CITY OF KIRKLAND
Planning and Community Development Department
123 Fifth Avenue, Kirkland, WA 98033
425.587.3225 www.kirklandwa.gov

File No.: DRV15-01554

Subject: **PARK LANE MIXED USE PROJECT DESIGN RESPONSE CONFERENCE
(CONTINUED FROM SEPTEMBER 8th MEETING)**

Design Proposal Packet

SITE PLAN

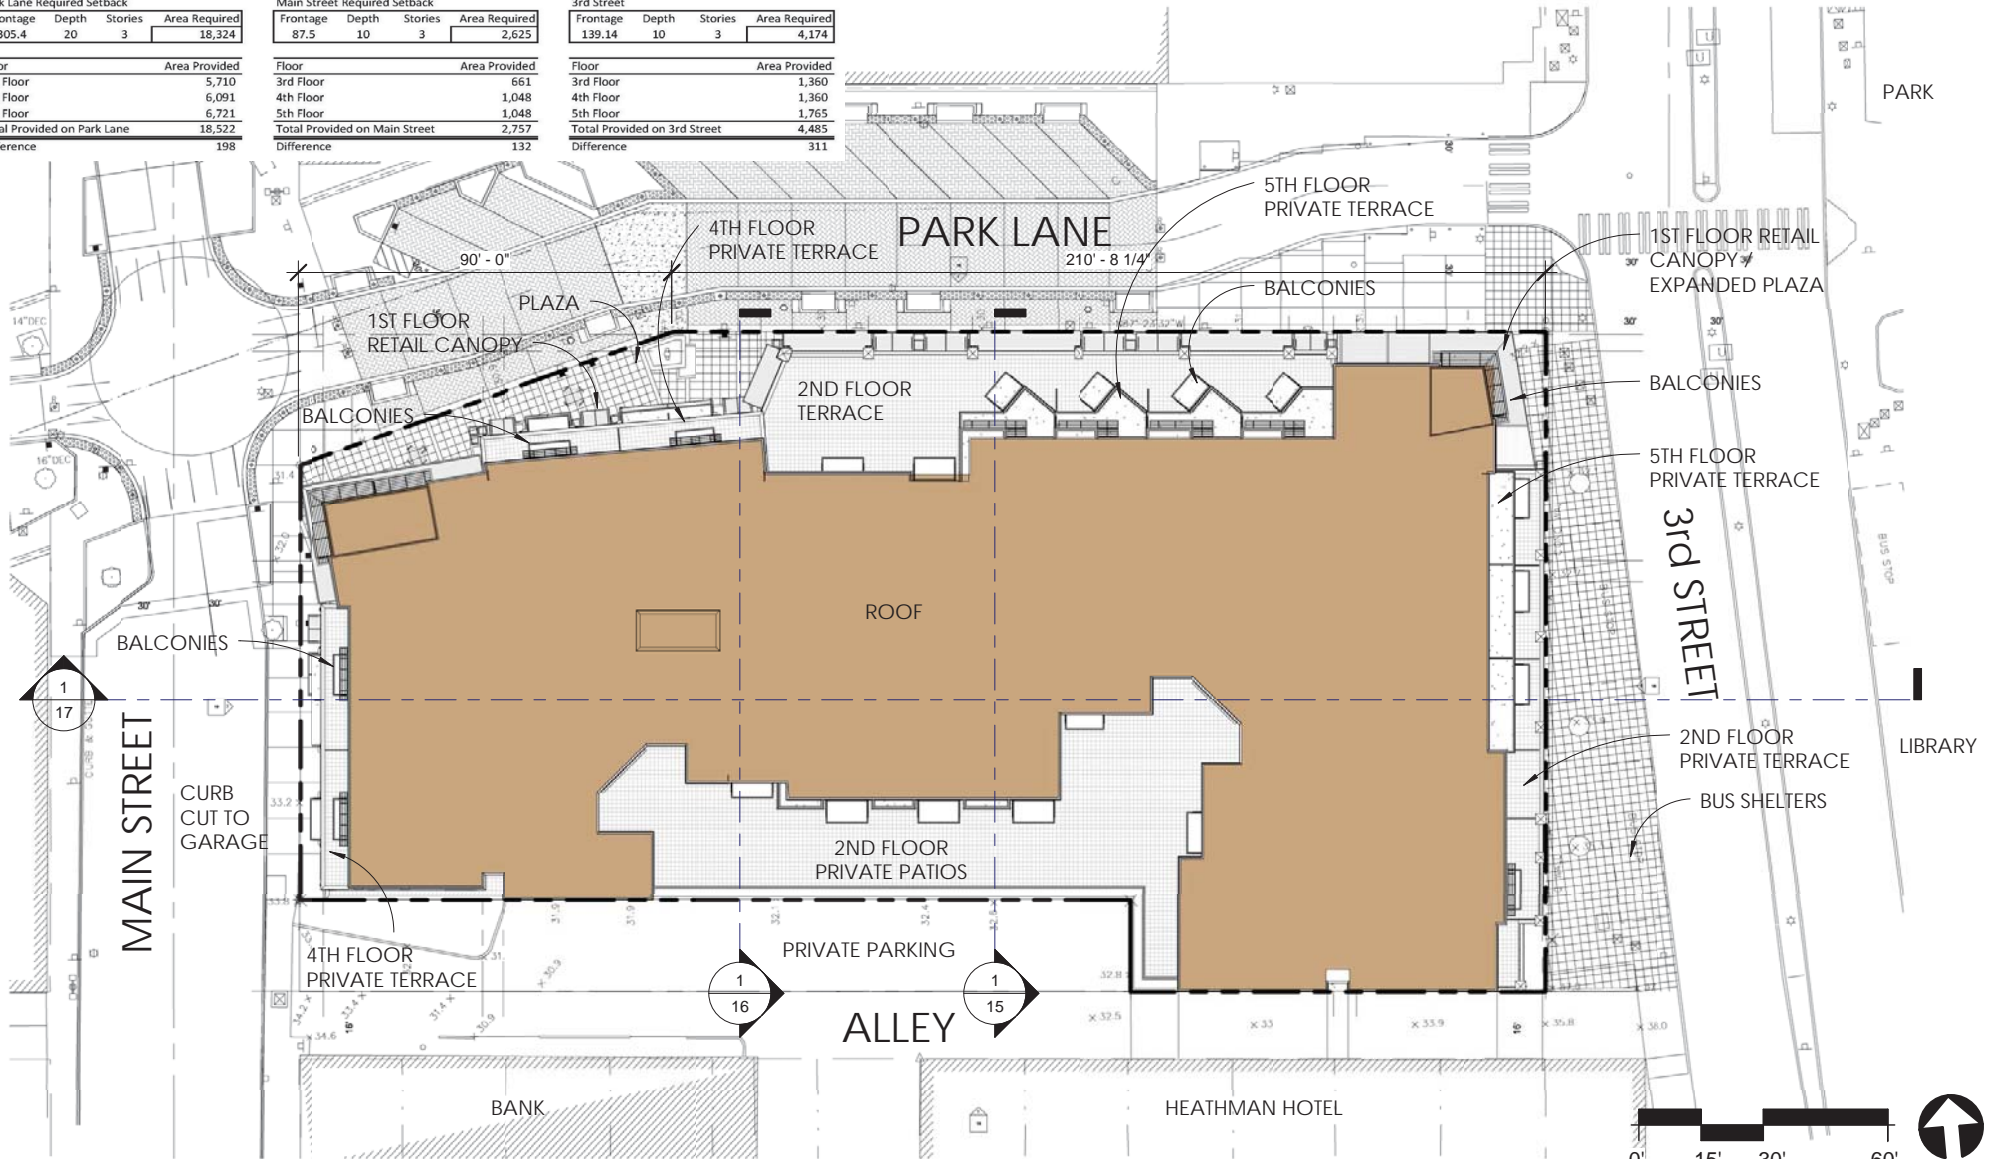
- M1:** DO NOT LIKE PROPOSED ARCADE AT NE CORNER. APPEARS TOO HEAVY. LARGE TERRACE FOR UNIT ABOVE, GIVE MORE TO PUBLIC REALM.
SEE SHEET 26.2. ARCADE HAS BEEN REMOVED. COMMERCIAL FRONTAGE ALIGNED WITH FLOOR ABOVE. UNIQUE CORNER CANOPY PROVIDED.

- M2:** PARK LANE COMMERCIAL FRONTAGE IS VERY LONG AND UNBROKEN. REVIEW DETAILING OF PARAPET WALL AND STOREFRONTS TO PROVIDE VARIETY & INTEREST. REMOVE ARCADE TO SHORTEN LENGTH OF WALL.
SEE SHEETS 23.2-25 & 32 & 33. VARIETY & DETAIL HAS BEEN ADDED TO THIS FRONTAGE.

- M4:** LOBBY ENTRY IS STILL AN "ABRUPT" END TO PLAZA. REVIEW HOW TO SOFTEN THIS EDGE.
SEE SHEETS 8 & 22. LOBBY WALL HAS BEEN SOFTENED WITH AN ANGLED PLAN TO OPEN UP MORE AT PLAZA & TURN CORNER.

M1: ARCADE HAS BEEN REMOVED. COMMERCIAL FRONTAGE IS SETBACK TO ALIGN WITH BUILDING ABOVE TO EXTEND EXISTING R.O.W. PLAZA AROUND CORNER.

M2: COMMERCIAL FRONTAGE FOOTPRINT HAS BEEN REVISED TO STEP IN AND OUT ALONG FRONTAGE AND PROVIDE DOOR ALCOVES AT COMMERCIAL ENTRIES TO PROVIDE ARTICULATION AND PEDESTRIAN INTEREST.

M4: THE LOBBY ENTRY WALL HAS BEEN ANGLED BACK TO OPEN UP AND SOFTEN THE END OF THE PLAZA. THE ANGLED WALL RELATES TO THE MULTIPLE ANGLES OF PARK LANE AND THE ANGLED MASSING OF THE UNIT BAYS ABOVE.

L2: BUILDING EDGE HAS BEEN REVISED TO PROVIDE AREA FOR LANDSCAPE BEDS ALONG 3RD STREET FRONTAGE.

LEVEL 2 FLOOR PLAN

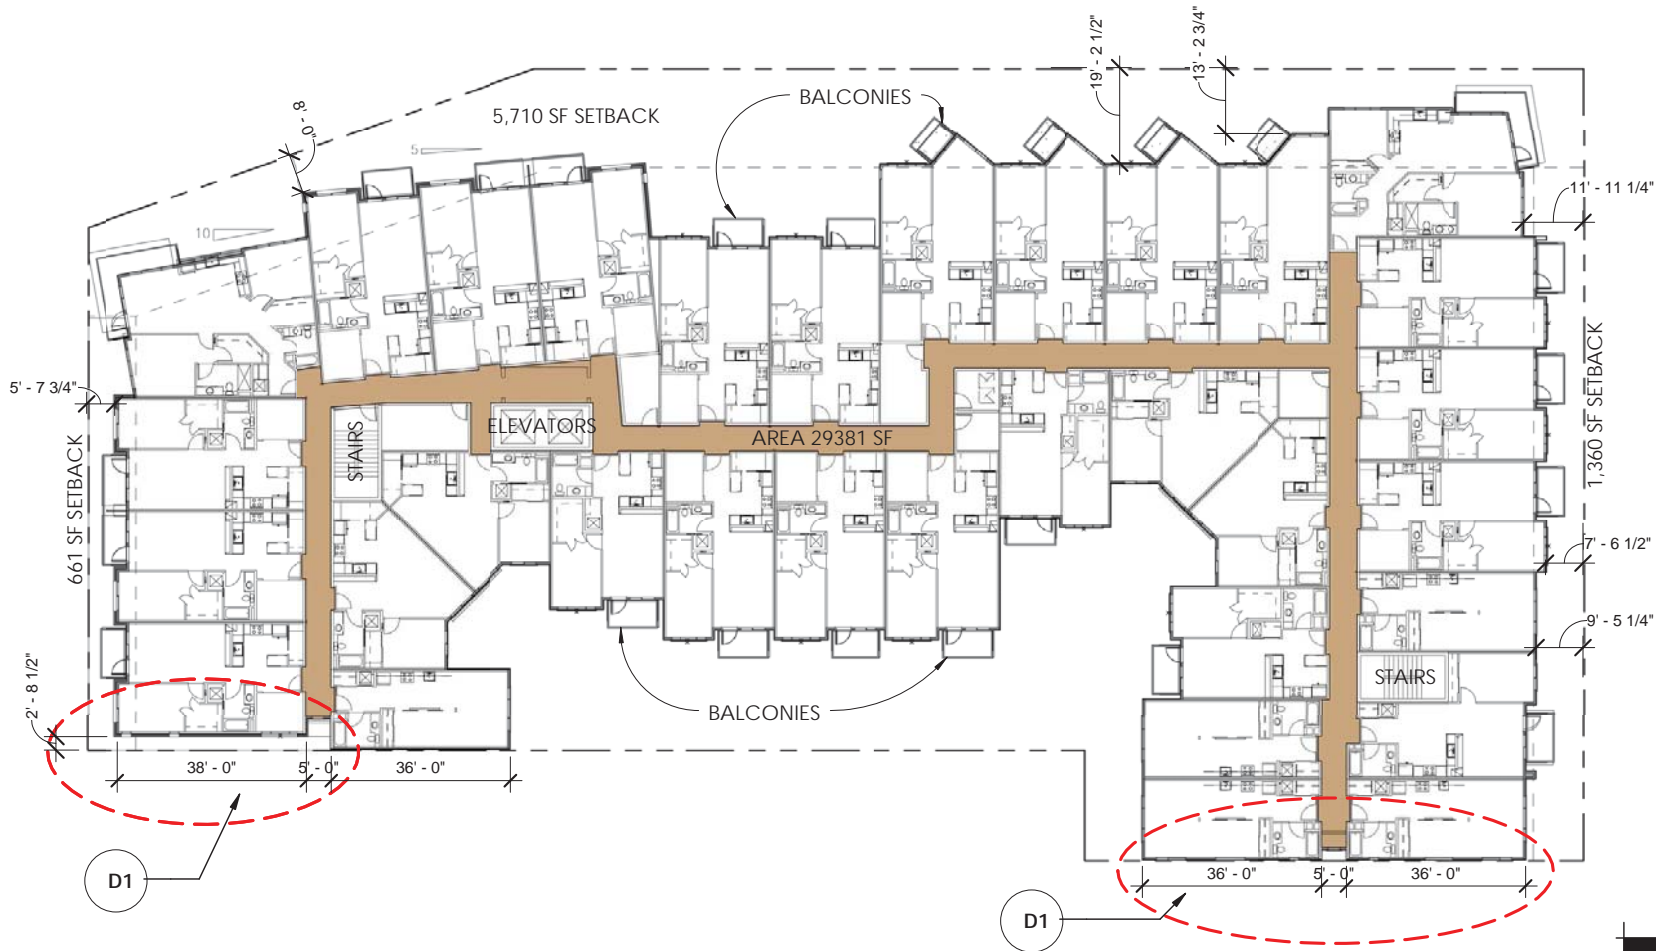
- D1:** BLANK WALLS ON SOUTH ELEVATION (ALLEY). MAXIMIZE THE AREAS WHERE THERE CAN BE WINDOWS. INCREASE NUMBER OF WINDOWS &/OR SIZE OF WINDOWS.
PROVIDE MORE DETAIL / COLOR, TEXTURE, RELIEF AT THE BLANK WALL THAT CANNOT HAVE ANY WINDOWS DUE TO PROPERTY LINE CONDITION.
SEE SHEET 27.2 FOR ADDITIONAL WINDOWS ADDED AT EAST END OF ALLEY. SEE SHEET 28.2 FOR ADDITIONAL WINDOWS ADDED & COLOR/TEXTURE AND MATERIAL CHANGES TO BLANK WALL CONDITION AT WEST END OF ALLEY.

M1: ARCADE AND LARGE UPPER TERRACE HAVE BEEN REMOVED. CORNER IS OPEN TO GROUND TO MAXIMIZE PUBLIC OPENSOURCE.

M4: THE LOBBY ENTRY WALL / TERRACE PARAPET WALL HAS BEEN ANGLED BACK TO OPEN UP AND SOFTEN THE END OF THE PLAZA. THE ANGLED WALL RELATES TO THE MULTIPLE ANGLES OF PARK LANE AND THE ANGLED MASSING OF THE UNIT BAYS ABOVE.

D1: ADDITIONAL WINDOWS HAVE BEEN ADDED TO END UNITS TO REDUCE THE AMOUNT OF "BLANK" WALLS.

L2: BUILDING EDGE HAS BEEN REVISED TO PROVIDE AREA FOR LANDSCAPE BEDS ALONG 3RD STREET FRONTAGE.

L5: TERRACE EDGE HAS BEEN REVISED TO PROVIDE AREA FOR LANDSCAPE BEDS TO TRAIL DOWN GARAGE WALL.

COLOR PALETTES

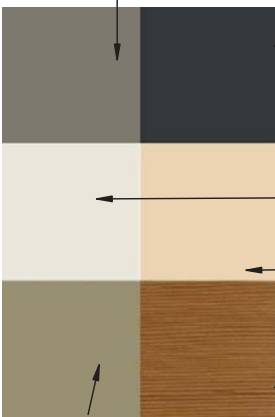
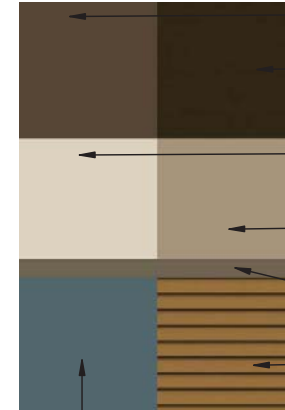
- C1:** DO NOT LIKE PROPOSED COLOR PALETTE. COLORS ARE TOO "LIGHT" AND "MUTED". PROVIDE MORE CONTRAST BETWEEN COLORS/MATERIALS.
SEE SHEETS C & C1 FOR REVISED COLOR PALETTE.

- C2:** BRICK SELECTION APPEARS TO BE "DATED." BRICK WALLS APPEAR VERY "FLAT." PROVIDE ADDITIONAL BRICK DETAILING TO CREATE TEXTURE / RELIEF.
SEE SHEETS C & C1 FOR REVISED COLOR PALETTE AND SHEETS 33-35 FOR BRICK DETAILING.

- C3:** MIXED OPINIONS ON DARK ACCENTS (BALCONIES / STOREFRONT / CORNICES). SOME LIKED THE CONTRAST, OTHERS THOUGHT IT ADDED TO THE OVERALL MASS OF THE BUILDING.
REVISED "DARK BRONZE" COLOR TO "MEDIUM BRONZE" FOR SOFTER CONTRAST.

- C4:** OPPOSED TO WHITE VINYL WINDOWS, APPEAR "INEXPENSIVE" AND WILL LOOK "DIRTY" ON ADJACENT LIGHT PANEL WALL COLOR.
REVISED WINDOW COLOR TO "TAN" THROUGHOUT.

BRICK: REVISED TO A WARM BROWN BRICK BLEND OF UP TO (3) COLORS. SEE SHEET 35 FOR DETAILS.

PAINT: WARM NEUTRAL TONES OF CREAM & KHAKI WITH SUFFICIENT CONTRAST BETWEEN COLORS. DARK ACCENTS FOR PAINTED TRIM AND CORNICES PROVIDE ADDITIONAL CONTRAST. DEEP BLUE ACCENT COLOR PROVIDES VIBRANCY TO SCHEME AND IS A "COMPLIMENTARY" COLOR TO ADJACENT BUILDINGS.

WOOD: CEDAR SIDING ACCENT HAS BEEN REPLACED WITH "WOODTONE" FIBER CEMENT LAPPED SIDING. THIS WILL ENSURE LONG TERM QUALITY FINISH AND PROVIDE THE WARMTH, COLOR AND TEXTURE OF REAL WOOD. NOW ABLE EXPAND THE QUANTITY AND LOCATION OF THIS ACCENT COLOR.

METAL: DARK BRONZE METAL HAS BEEN REPLACED WITH "MEDIUM BRONZE" FOR LIGHTER COLOR/DEPTH WHILE MAINTAINING DESIRED CONTRAST.

WINDOWS: WHITE VINYL WINDOWS HAVE BEEN REVISED TO A "TAN" COLOR. DARK ACCENT WINDOW TRIM PROVIDES ADDITION CONTRAST AND DEPTH TO FACADES.
